From: "Carol O'Claire" <COClaire@dps.state.oh.us>
To: <jda1@nrc.gov>
Date: 01/16/2008 9:26:28 AM
Subject: NEI 06-04, Rev. 1

EMA would like to submit the following comments to NEI 06-04, Nuclear Energy Institute, "Conducting a Hostile Action-Based Emergency Response Drill":

Appendix C, Pre-Drill Tabletop Guidelines

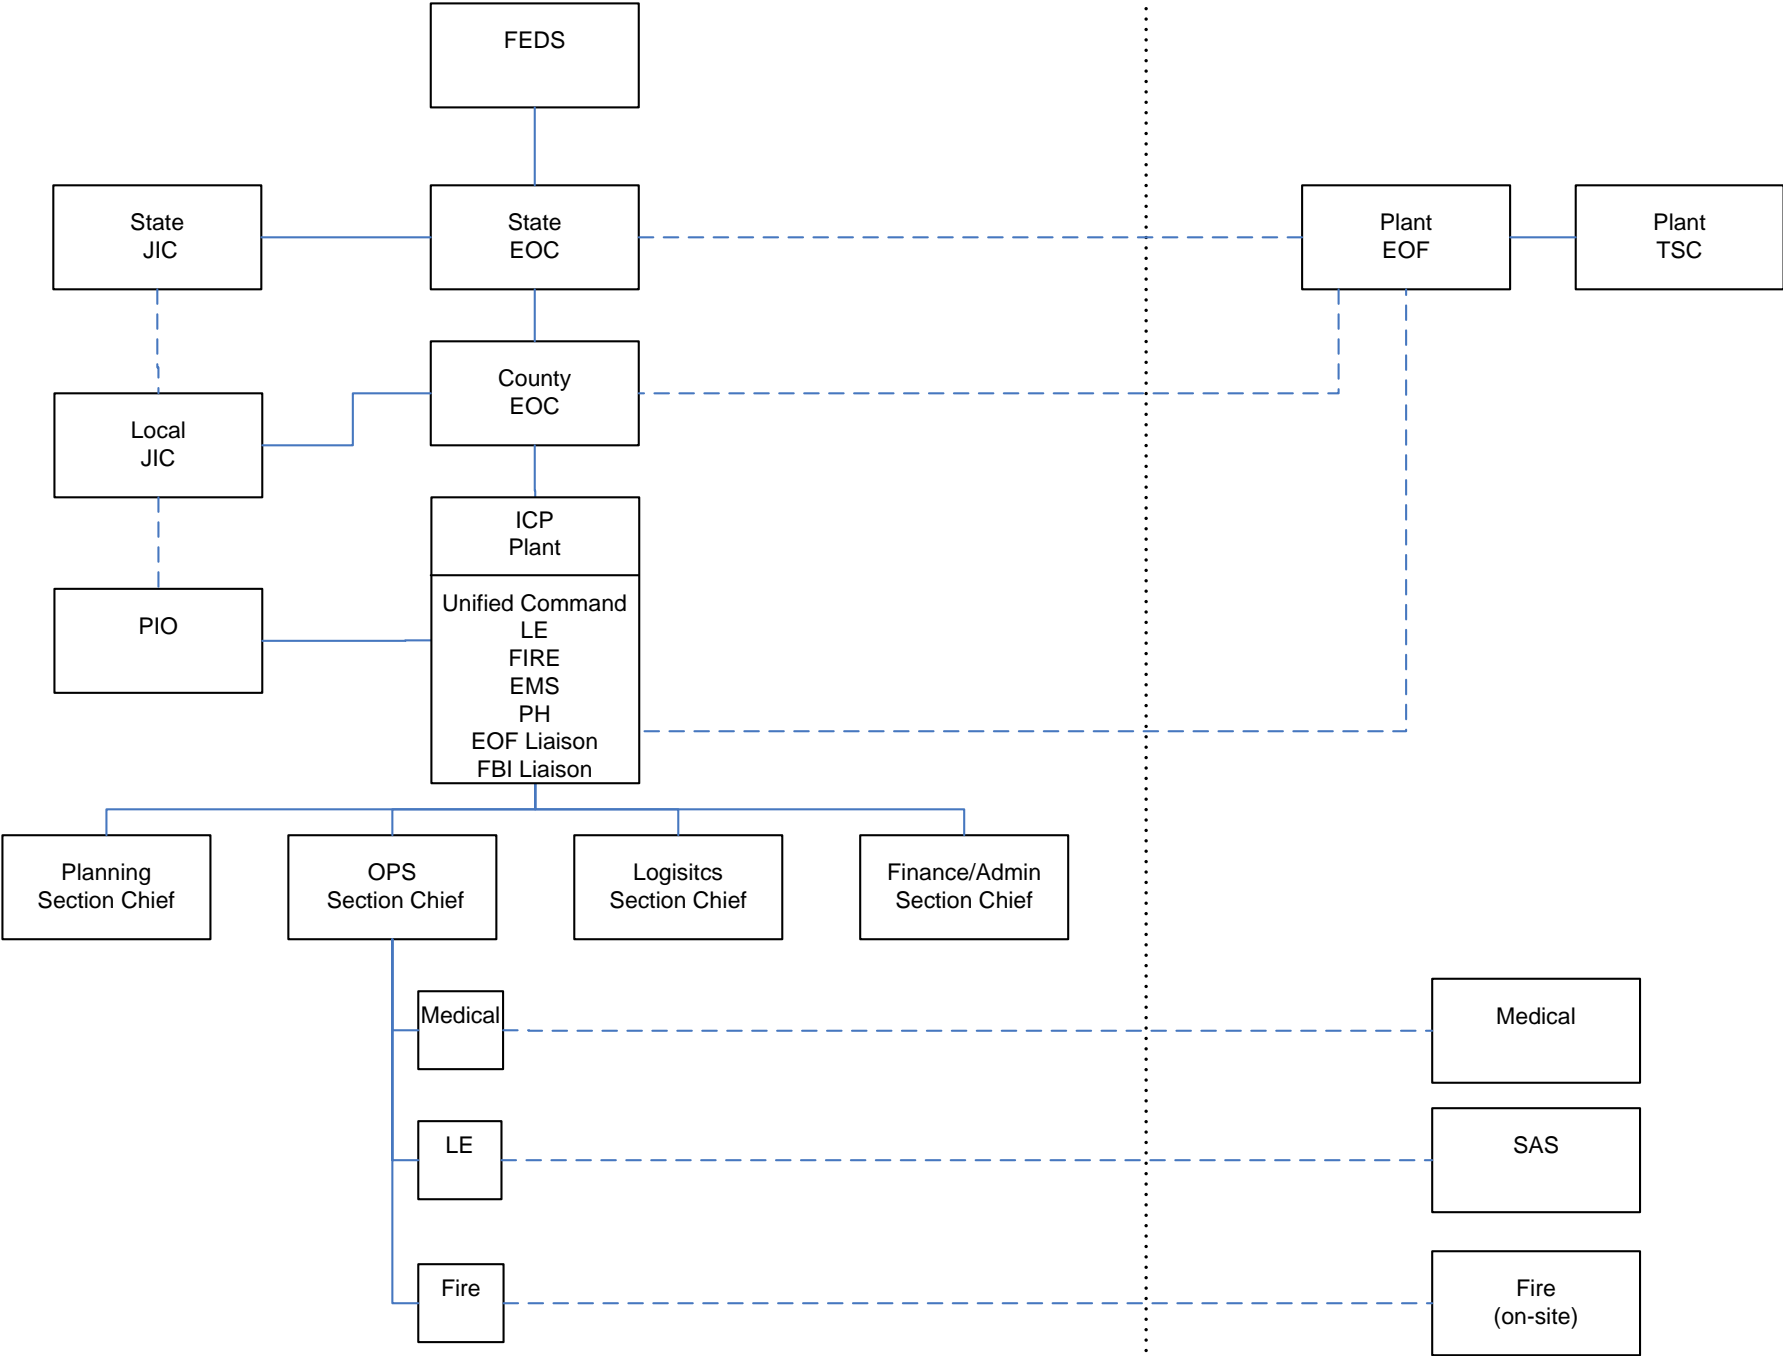
This diagram caused confusion for drill participants. Charts are needed that correctly represent ICS organizational structure.

Attached is an "example" of a more correct diagram.
